30 Mary Natasha Court

Presented by John Ramirez

Request Approval for 10 Minor Variances

Variance # 2

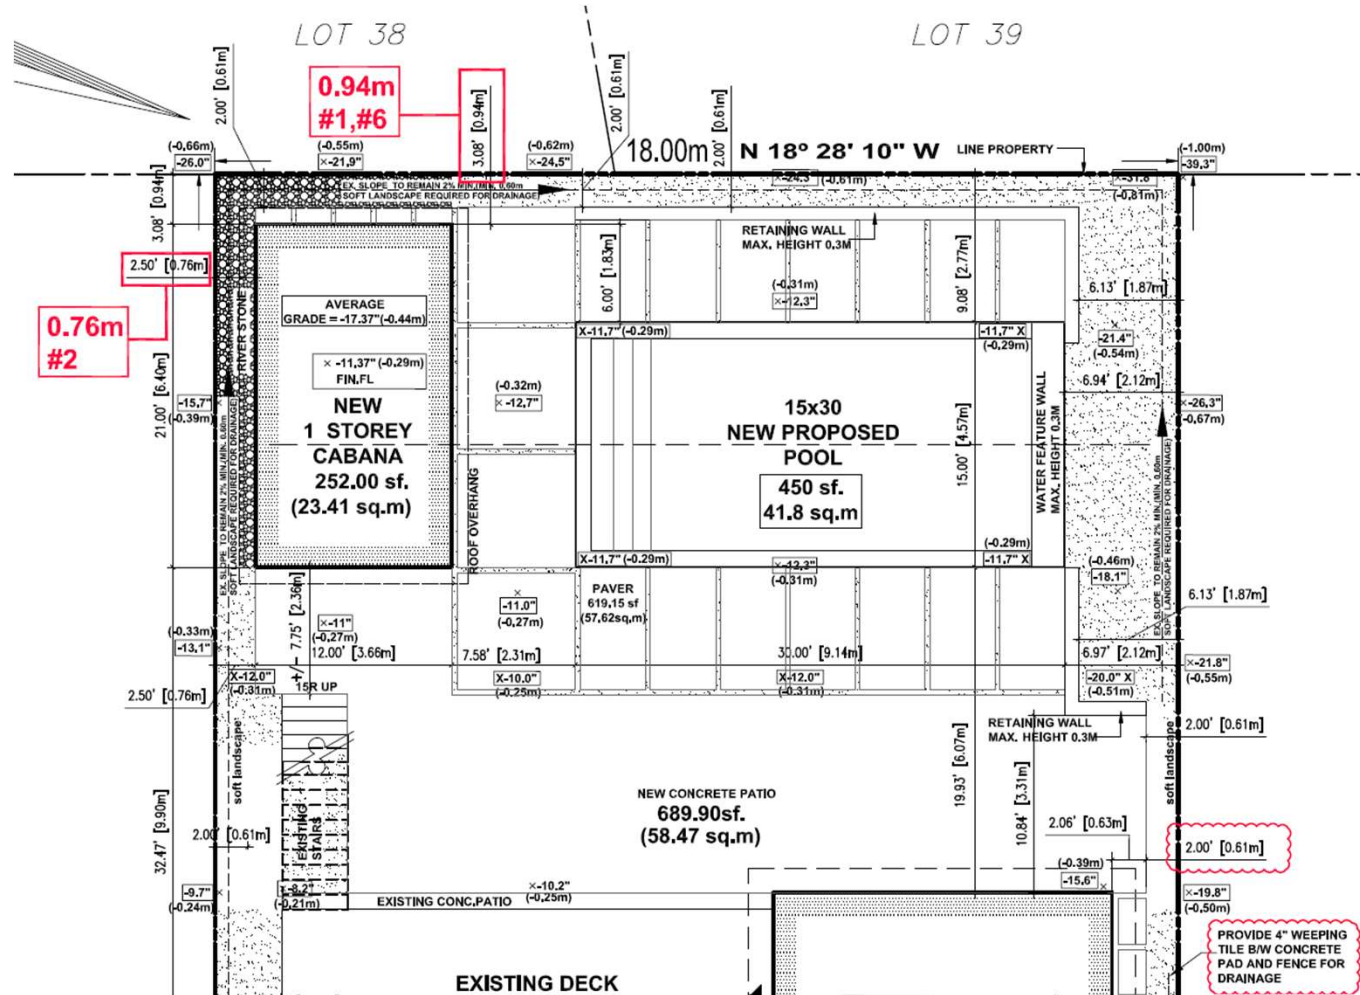
1. No objection to **Variance 2** as the reduction to the interior side yard setback is minor in nature and will not have adverse impacts on the neighbouring property. The interior side yard setback of 0.76 m also maintains an appropriate area for access and drainage.

Variances # 5 & 7 Lot Coverage

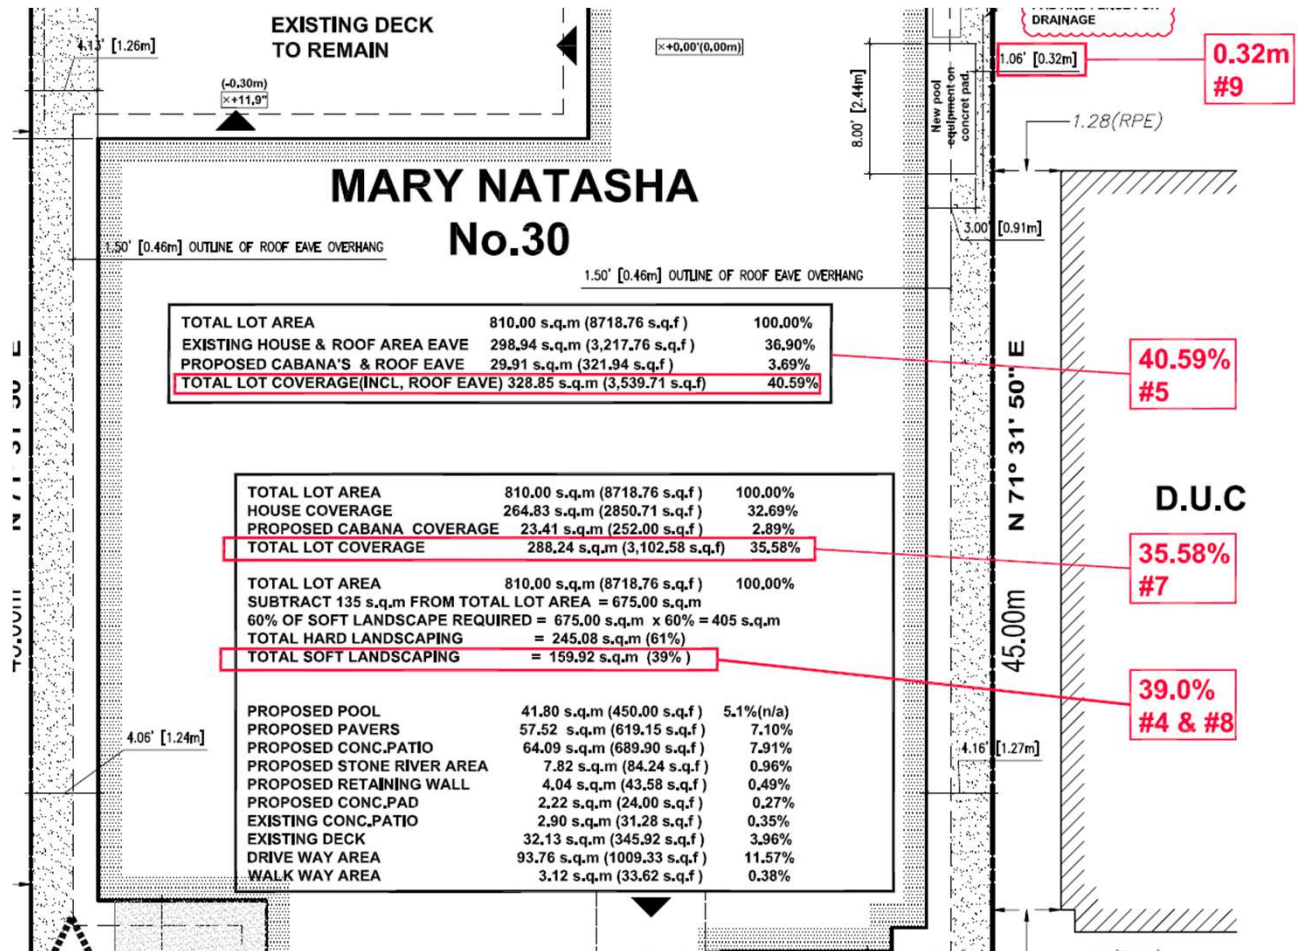
4. No objection to **Variances 5 and 7** for the increase in lot coverage. The increase in total lot coverage will not pose a significant visual impact to the adjacent properties and is minor in nature relative to both Zoning By-law requirements.

Variance # 9

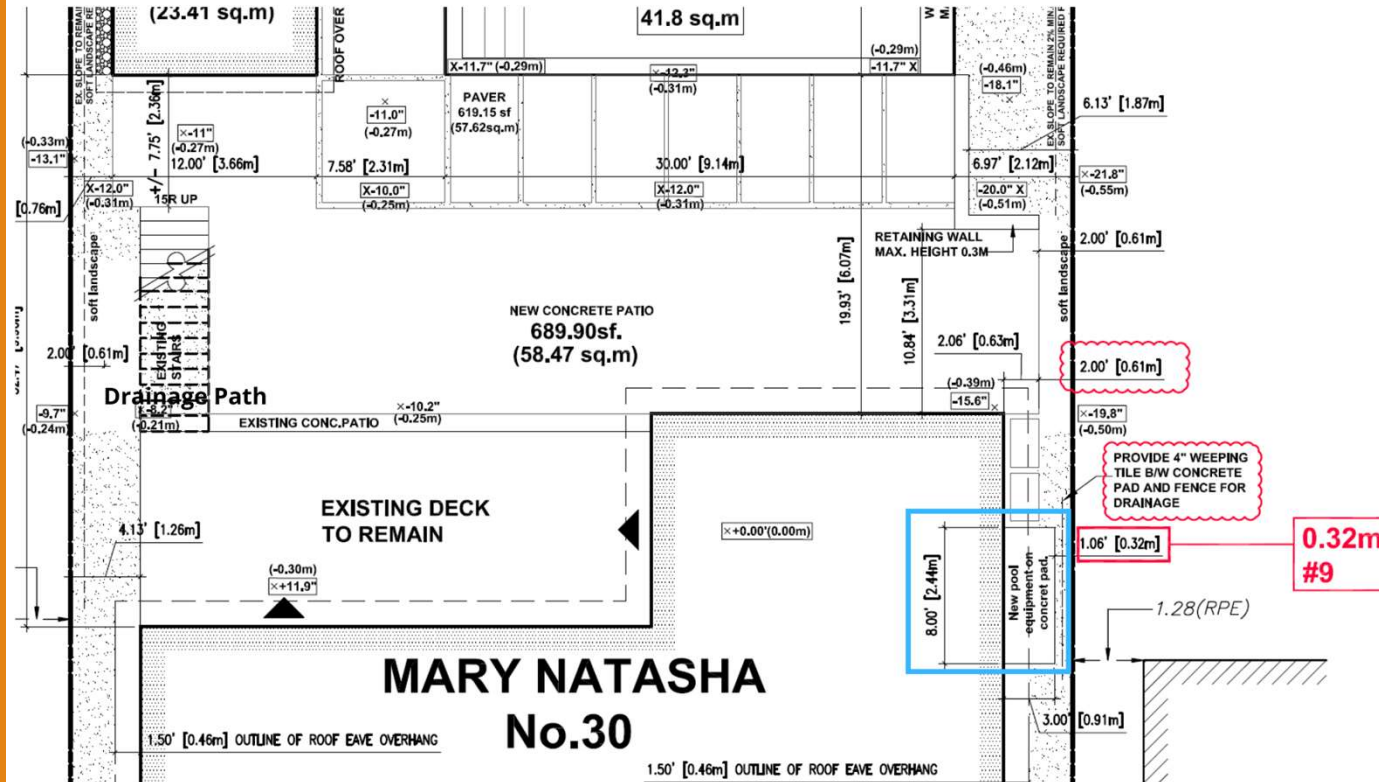
5. No objection to **Variance 9** as access to the rear yard will be maintained through the southern side yard. The Development Engineering Department has also reviewed the proposal and is satisfied that drainage will be maintained through the introduction of weeping tiles.
